# Community Association Responses

**RE: LOC2022-0227| 201 10 St NW | DC to DC/MU-2h50f9.0**

**RE: LOC2022-0227| 201 10 St NW | DC to DC/C-COR1**

Figure 1: Map 3.2 Maximum Densities

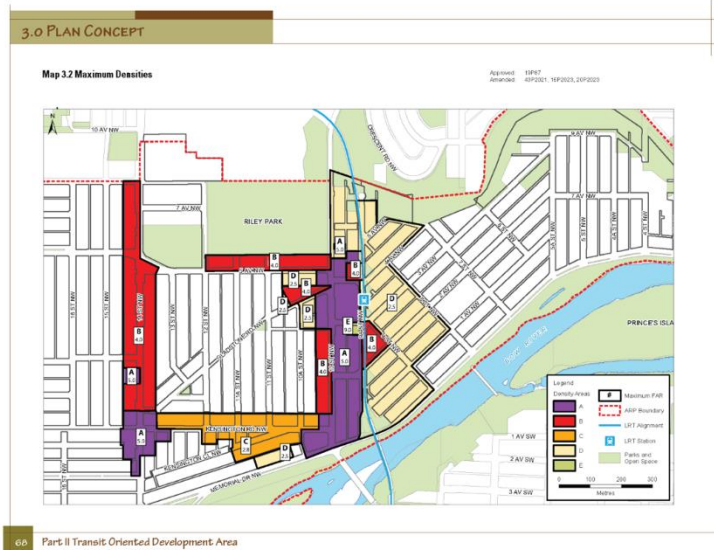
The HSPC is typically supportive of the continued progress towards the HS ARP vision of increased densification in the Hillhurst Sunnyside community. The HSPC is challenged with understanding how an application can apply for a FAR that is 4.0 greater than the recommended policies, as outlined on Map 3.2 of the HS ARP (Figure 1). We are further challenged with understanding how an application can apply for a maximum height that is 24m greater than the recommended height as outlined on Map 3.3 of the HS ARP (Figure 2).
